**Subject:** Zoning By-law Amendment Application A 08/20  
Steele Valley Developments Ltd., 334979 Ontario Ltd., Pickering Square Inc., and  
Pickering Square (1986) Inc.  
(1300, 1360, 1450 and 1550 Kingston Road)

## **1. Purpose of this Report**

Figure 2: Submitted Conceptual Plan for 1450 Kingston Road

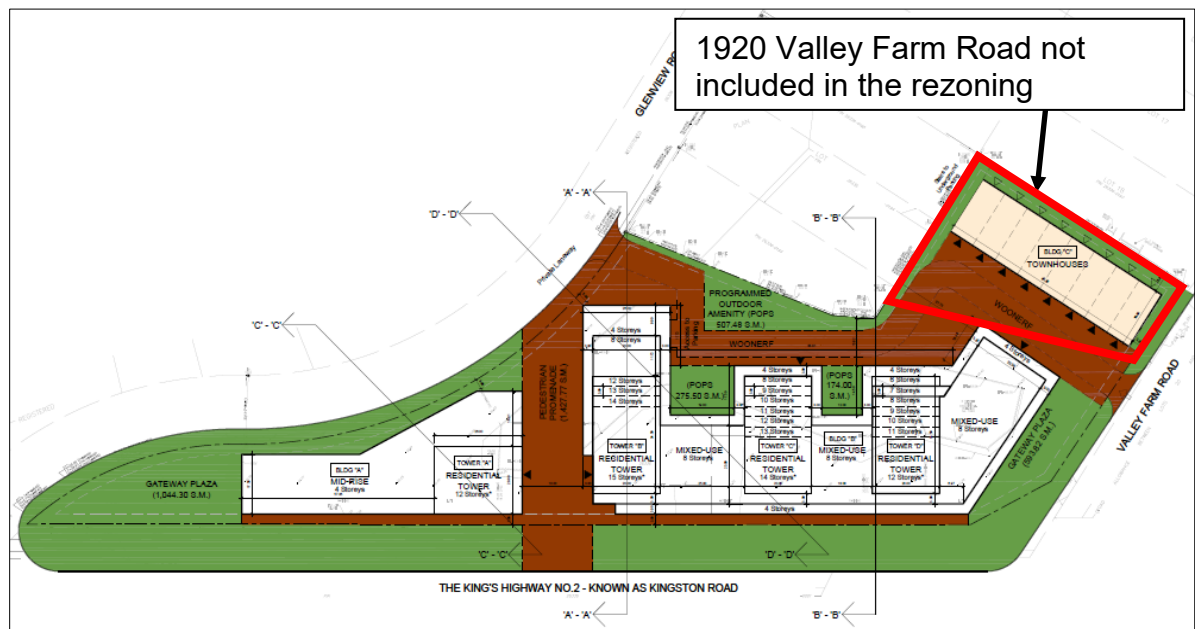
- assess the appropriateness of the proposed vehicular accesses at the 4 subject properties;
  - evaluate the appropriateness of the request to exempt the proposed building height from a 45-degree angular plane requirement adjacent to street townhouses on Valley Farm Road, north of 1550 Kingston Road;
